Re: Docket No. 40-8027

SEQUOYAH FACILITY RAFFINATE SLUDGE DISPOSAL

RESPONSE TO SCIENCE APPLICATIONS, INC.
QUESTIONS OF APRIL 17, 1981

FIG 1:

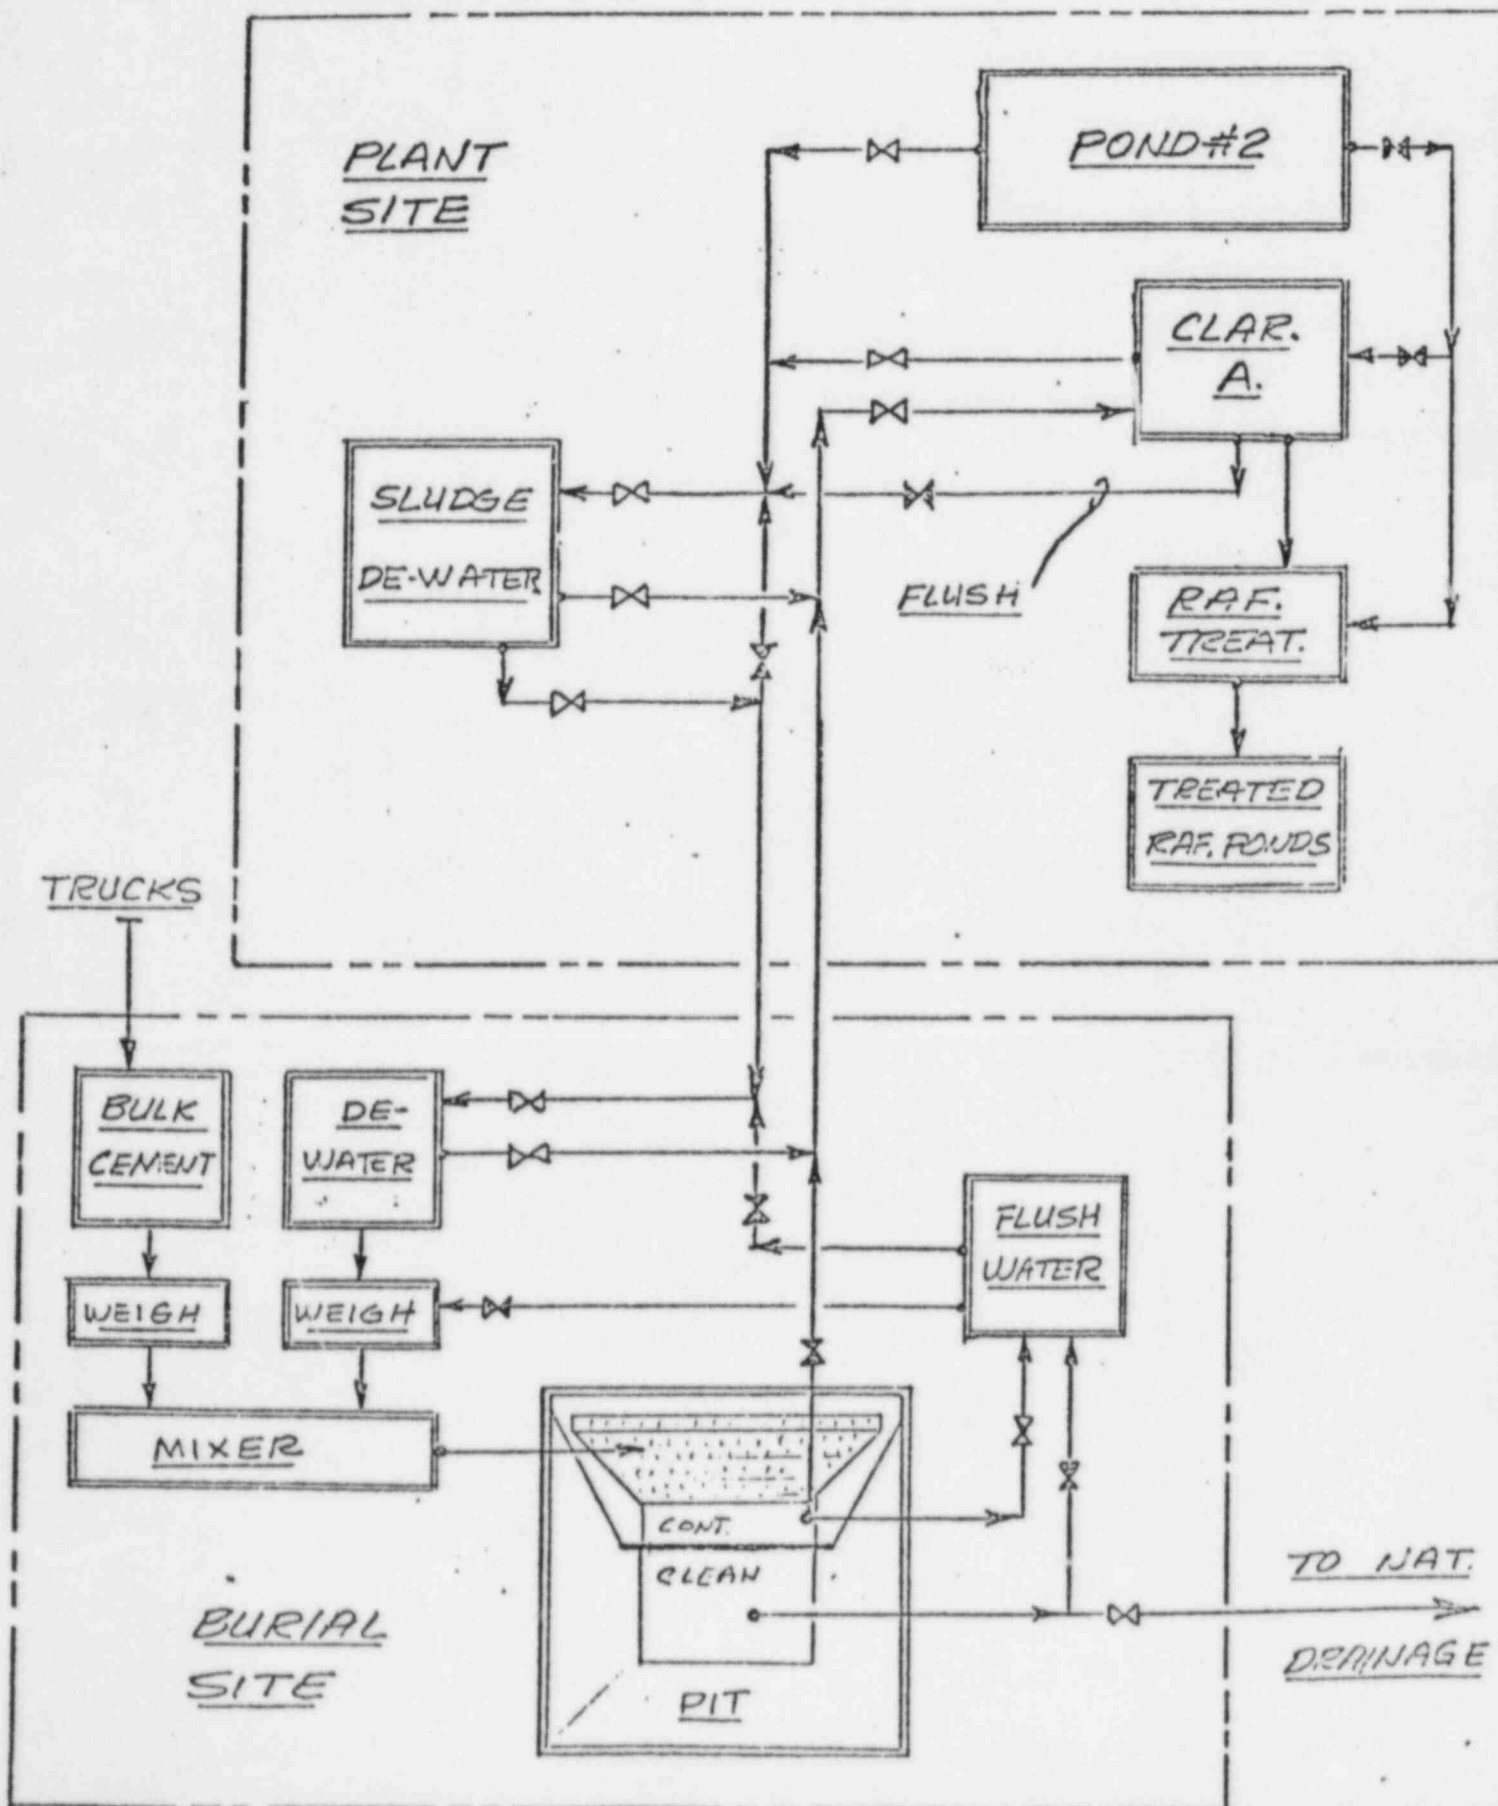
1. Describe the general system to be used for processing the waste, including in the description all of the major processing, storage and effluent control components. This description should address not only the radioactive portions but also the non-radioactive portions of the process (asphalt or cement storage and handling).

The Sequoyah facility generates 7.2×10^6 gallons per year of process raffinate. This raffinate is gravity fed from hold tanks in the process Solvent Extraction section to the Clarifier Basins for treatment and subsequent disposal. The raffinate is neutralized by NH_3 addition generating a solid hydrous precipitate which settles out forming the waste sludge. Clarified raffinate supernatant is transferred by a small pump to another clarifier Basin and from there to a treatment area where soluble radionuclides are removed by contact with barium chloride. The clean raffinate is then transferred to Raffinate Holding Pond #3 for further disposition.

Settled waste sludge is pumped from the Clarifier Basins and Storage Pond #2 by means of a barge mounted diaphragm pump to four primary dewatering tanks of twenty thousand gallon capacity each. There, the sludge is further settled facilitating removal of more clarified raffinate which is returned to the Clarifier Basins or

Pond #2. The settled sludge is pumped to the disposal site for final treatment. The plant and burial site equipment is shown in drawing number 290-M-1011 presenting the proposed sludge treatment process. The process flow diagram for sludge disposal is shown in Figure 1.

The settled sludge from the primary dewatering tanks is pumped 8,300 feet to the burial site treatment area through a 4 inch pipeline. The treatment area is 140 feet higher than the primary dewatering tank location. A 20,000 gallon surge tank receives the sludge at the burial site where it is allowed additional settling time. Any clarified raffinate is decanted and gravity fed through a 4 inch waste water line that returns to the sludge dewatering plant at the raffinate treatment area.

Settled sludge from the surge tank is discharged to a 1000 gallon capacity sludge measuring tank where the sludge volume is adjusted for the proper cement mix. Approximately 20,000 gallons per day of sludge is processed in this manner.

Dry cement is stored in a 175 ton silo from which 138 tons is consumed per day. Trucks deliver the dry cement and transfer it to the storage silo by air conveyors. Cement dust is controlled by bin vents. Screw feeders deliver dry cement from the silo to a 1,000 gallon capacity measuring tank so that a 1:1 volume ratio of sludge to cement can be obtained.

The sludge and cement measuring tanks empty into a 4.5 cubic yard batch cement mixer. After mixing thoroughly the cement/sludge material is emptied into a 5 cubic yard holding hopper. The holding hopper feeds into the suction side of a concrete pump which discharges into a flexible hose that deposits the material for permanent disposal into 4' x 4' x 8' ready made casting forms erected in the burial pit.
